**CITY OF BOULDER
CITY COUNCIL AGENDA ITEM**

AGENDA TITLE: Continuation of Concept Plan Review for feedback on an updated proposal for Shining Mountain Waldorf School to redevelop the campus with new lower/middle and high school buildings and entitle the remaining land for redevelopment as residences (999 Violet Ave, 1100 Violet Ave, 1101 Union Ave, 1179 Union Ave, 0 Locust Ave, 934 Locust Ave, 4395 Broadway). Reviewed under case no. LUR2018-00014.

To: Charles Ferro, Land Use Review Manager – CITY OF BOULDER Planning & Sustainability
Shannon Moeller – CITY OF BOULDER Planning & Sustainability
From: Adrian Sopher - SOPHER SPARN ARCHITECTS LLC
Project: SHINING MOUNTAIN WALDORF SCHOOL Concept Plan Review
Date: 27 December 2018

Re: CITY COUNCIL CONCEPT PLAN REVIEW – Key issue for 15 January Council Continuance Hearing

Figure 1 – BVCP Land Use Designations

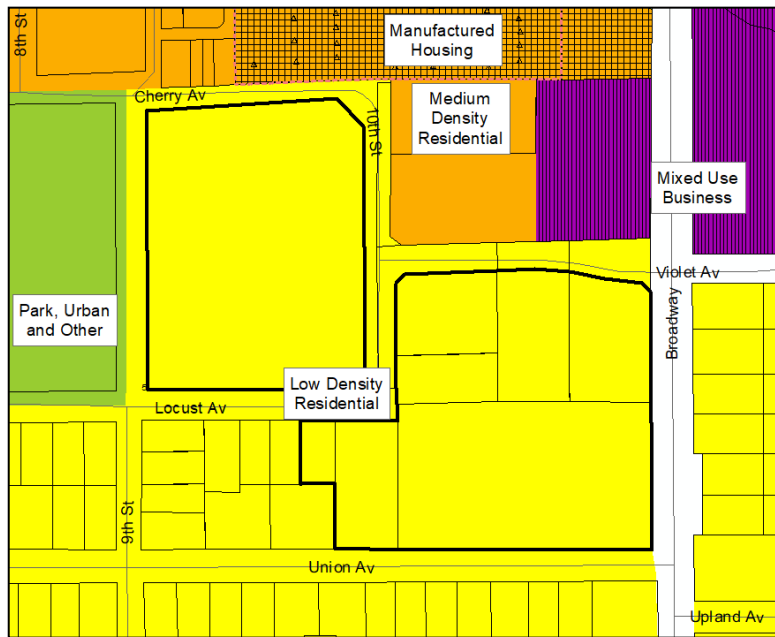
Consistency with Land Use Map and Zoning: The applicant's updated site plans are intended to be consistent with the [Boulder Valley Comprehensive Plan](#) (BVCP) land use designation and current zoning designation in order to move forward without the need for a land use map change and rezoning (as previously proposed). As depicted in **Figure 1**, the majority of the project site is located in the Low Density Residential (LR) land use

designation which is described as consisting of predominantly single-family detached units at a density of 2 to 6 dwelling units per acre.

Figure 2 – Zoning Districts

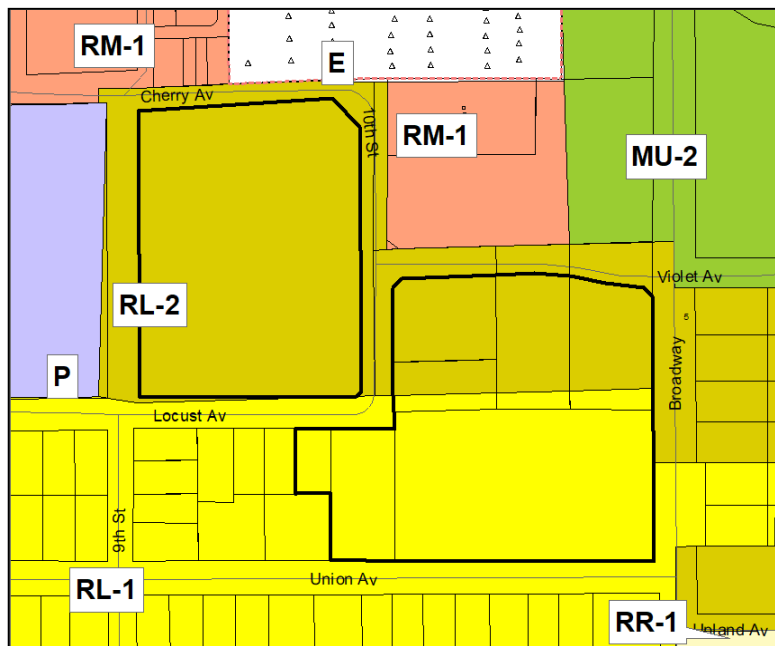
As shown in **Figure 2**, the area at the southwest corner of Broadway and Violet is zoned RL-2, Residential – Low 2, which is described as a medium density residential area used for small-lot development including duplexes, triplexes and townhouses, where each unit generally

has direct access to ground level. Based on these descriptions, the proposal for a townhome-style development would generally be more in keeping with the type of unit anticipated by the BVCP and current zoning designation.

Figure 3 – Floodplain

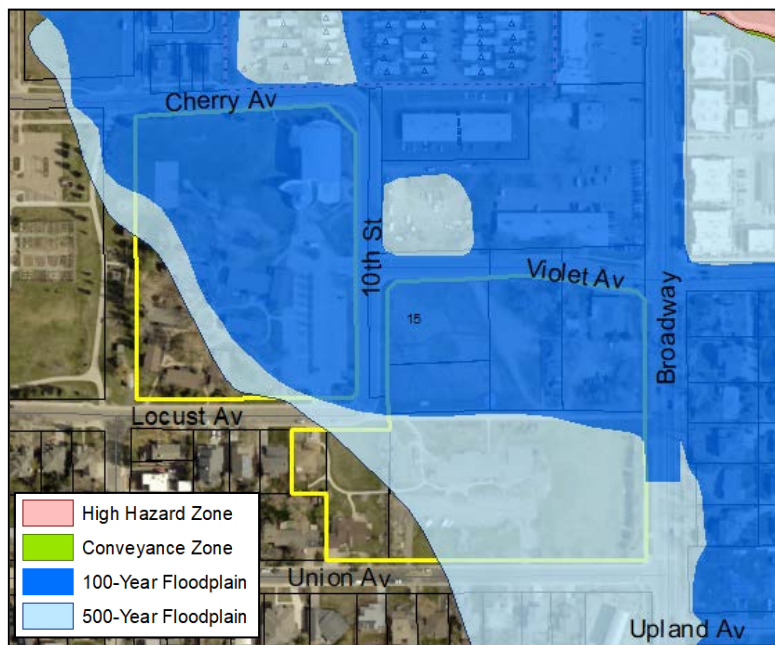
Floodplain: As shown in **Figure 3**, the site is impacted by the 100-year and 500-year floodplains of Fourmile Canyon Creek. All structures within the 100-year and 500-year floodplain require a Floodplain Development Permit. The school is

considered a critical facility and must also comply with [9-3-2\(i\)](#), B.R.C. 1981, which requires development and approval of an emergency management plan that addresses activities and procedures for effective response from flood and disaster events in addition to requirements for floodproofing or elevating all structures in the floodplain. Any new residential structures within the 100-year floodplain are required to be elevated 2 feet above the base flood elevation per [9-3-3\(a\)17](#), B.R.C. 1981. City flood control standards also require that longitudinal building axes are placed parallel to the predicted direction of flow of floodwaters in the 100-year floodplain. **Figure 4** depicts the 2013 flood event.
